Mountain Valley Pipeline Project

Individual Permit Application

Attachment C: Virginia Marine Resources Commission Permit
Modification Request and Materials

February 2021

Figure 3 Craig Creek Crossing Location

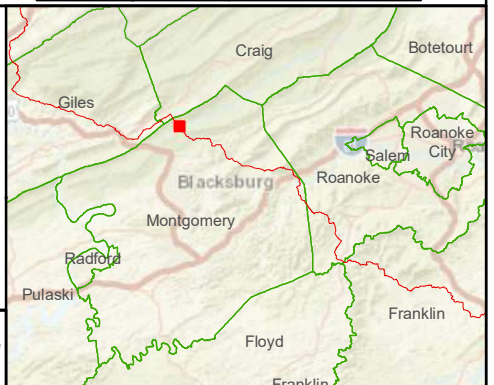
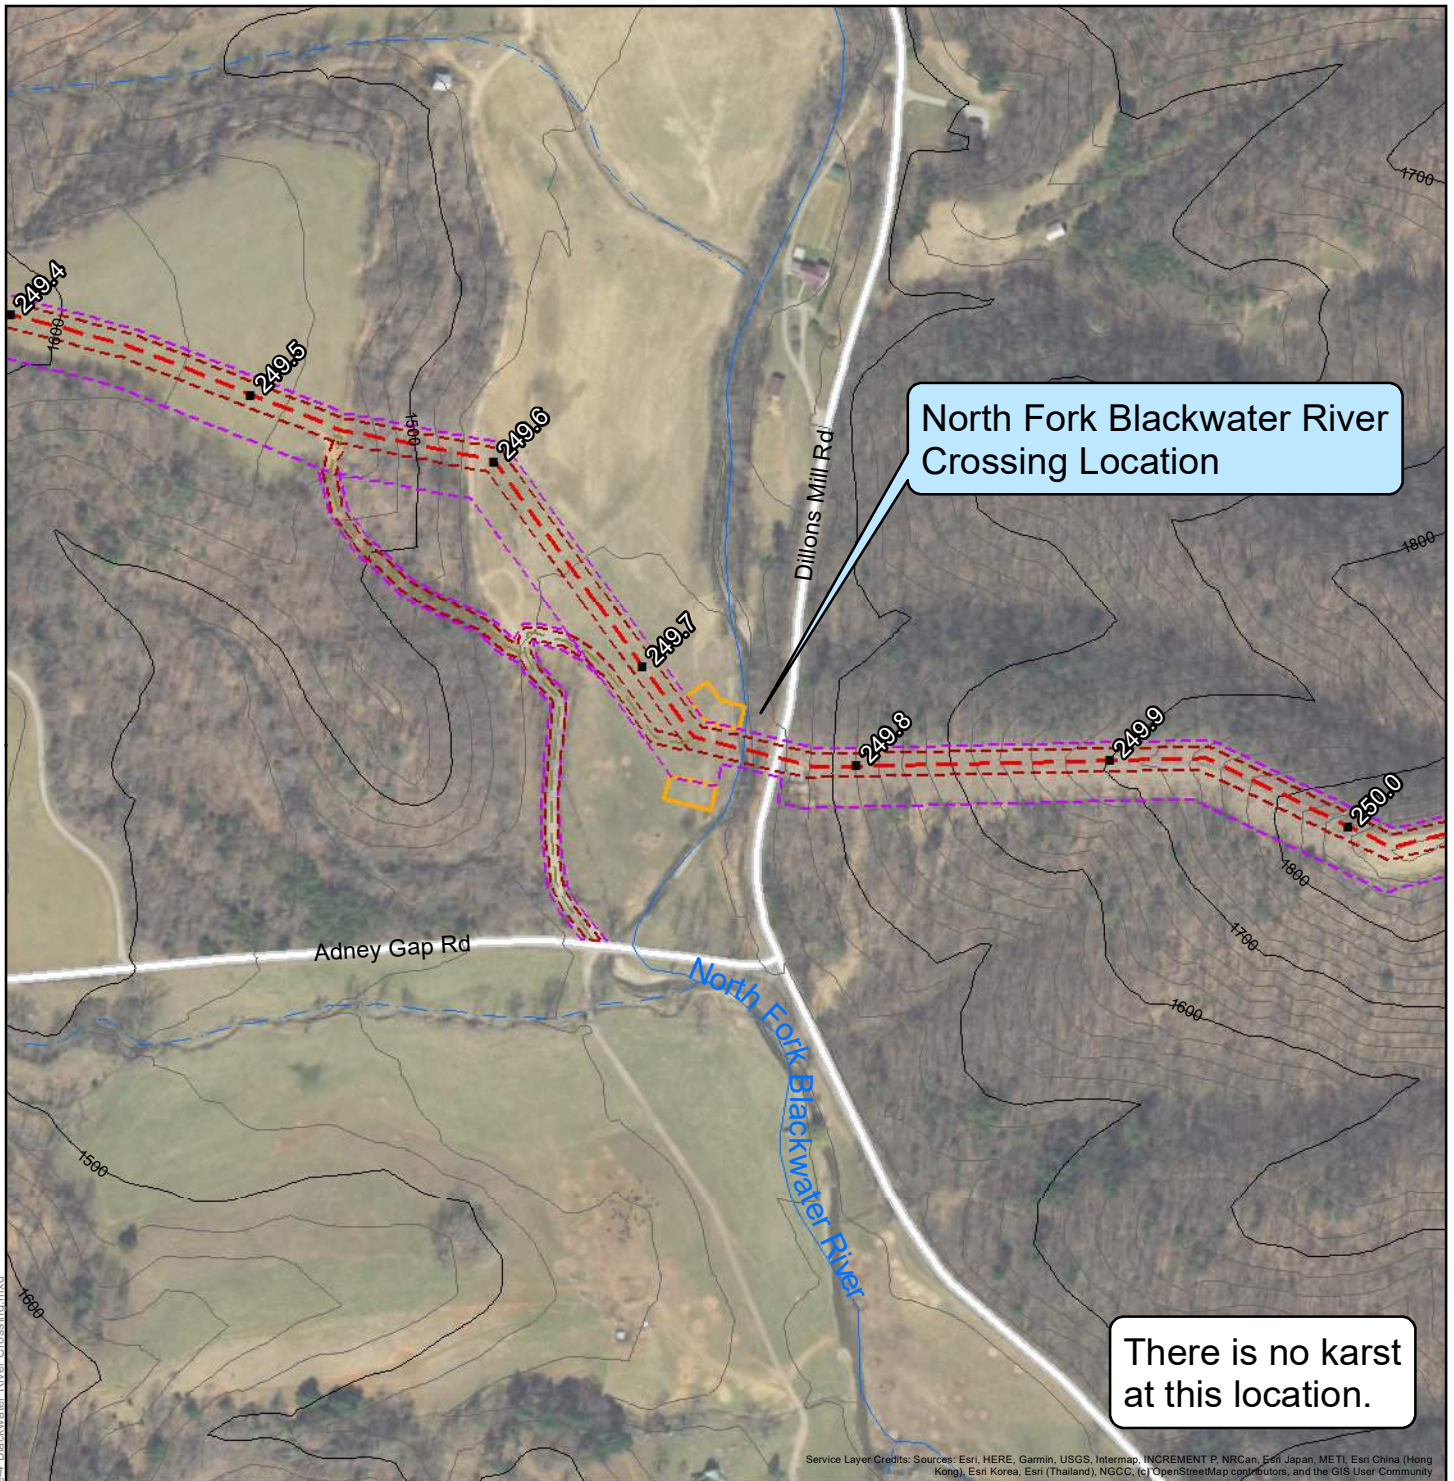
Craig Creek (Montgomery County, Figure 3 attached)

Orndorff comments: None of these crossing occur in areas with well-developed karst. In fact, only the Little Stony Creek crossing has any potential for encountering karst, albeit very small. The crossing is show on the Gile County Geology Map as taking place through alluvial deposits (mostly sandstone gravels, cobbles and ,boulders) overlying the calcareous shales and thin argillaceous (clay-rich) limestones of the Reedsville, Eggleston, and Mocassin Formations. While these formations occasionally host small caves and very small karst groundwater systems, this is generally only observed when they crop out on mountain slopes above the more massive limestones of Middle Ordovician age, that host the most significant cave and karst development. I think you are unlikely to encounter any karst associated problems at the Little Stony Creek Crossing, and that if you did the method chose (conventional bore) would cause only minimal impact. The only other concern here is that Little Stony Creek sinks (partially or completely depending on flow) into the limestone underlying its bed downstream of the crossing. This water has been traced to a spring on the New River called the Klotz Quarry Spring, which is identified in the 2018 dye tracing report prepared by DCR for Draper Aden Associates and MVP. MVP should be prepared to set up mitigation at the Klotz Quarry Spring as well as the surface flow of Little Stony Creek, in case of the unlikely event of a discharge of contaminants or significant sediment to Little Stony Creek. It may be wise to 1) have mitigation equipment, materials, and crew on standby during the crossing operation, 2) arrange ahead of time access to the spring, and 3) visit the spring to be able to address any accessibility issue preemptively.

Figure 4 North Fork Blackwater River Crossing Location

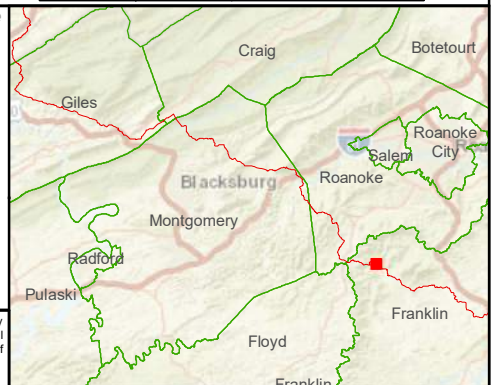
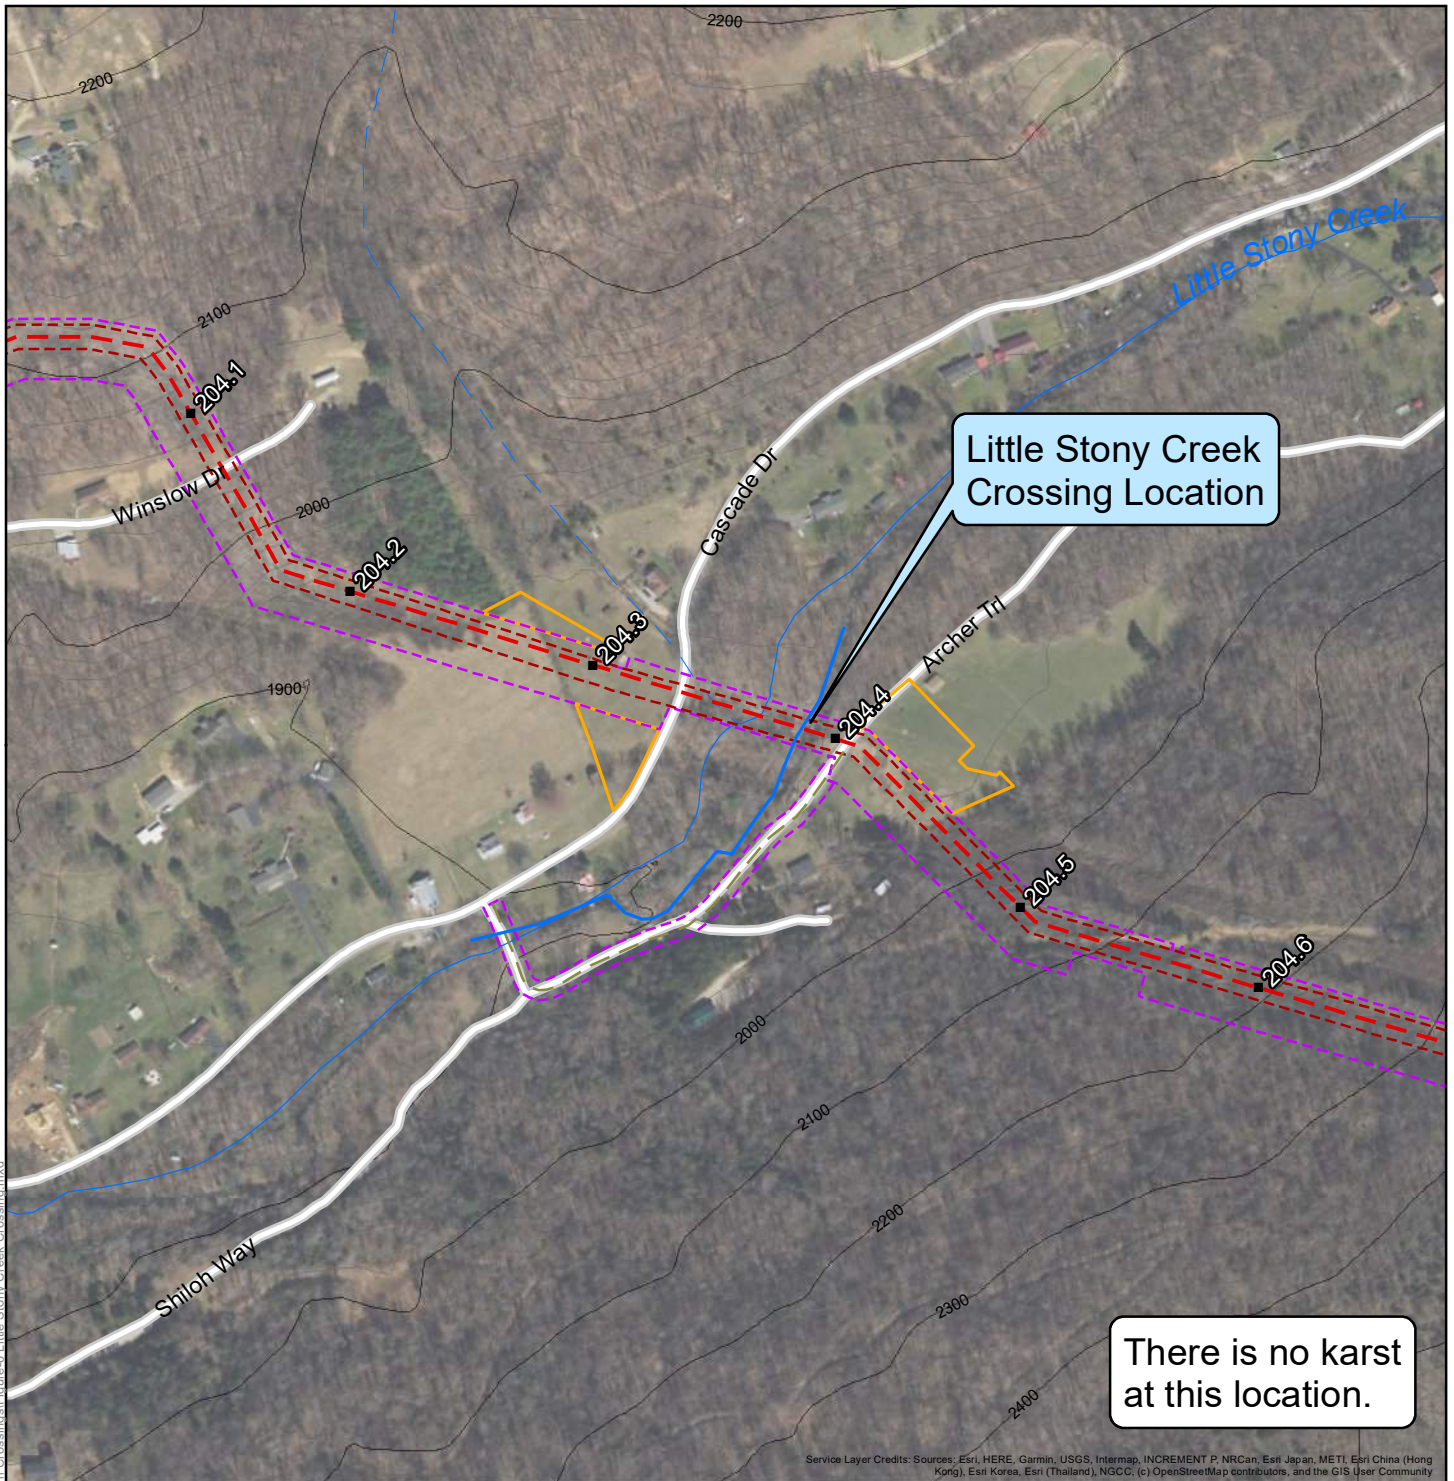
North Fork Blackwater River (Franklin County, Figure 4 attached)

Figure 6 Little Stony Creek Crossing Location

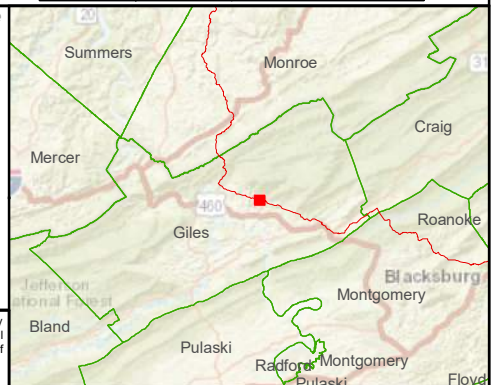
Little Stony Creek (Giles County, Figure 6 attached).

MVP Response: Based on the Karst Area Contingency Guide developed for the project by Draper Aden Associates in March of 2018, the Little Stony Creek stream was identified through dye tests as located within the Klotz Spring karst watershed. This document is attached for your reference. Per the guide, the Project's approved Spill Prevention, Control, and Countermeasure (SPCC) Plan and Unanticipated Discovery of Contamination Plan for Construction Activities in Virginia provides contingency plans and emergency procedures and will therefore be followed for notifications and emergency procedures should they become necessary. Additionally, Section 4 of the SPCC Plan includes specific measures to support MVP construction in karst terrain. As an additional preparative measure, the project is currently working on securing

access to the Klotz Spring area. In doing so, MVP can preemptively address any sedimentation concerns as a result of the conventional bore crossing of Little Stony Creek. Spill kits and other materials will be staged specifically for response to the Klotz Spring area. It is also important to note that the Karst Specialist Team will brief the drilling crews in advance of the Little Stony Creek bore about potential karst hazards and will remain on call to advise the crews and respond if any karst hazards are encountered unexpectedly (in accordance with the Karst Mitigation Plan).
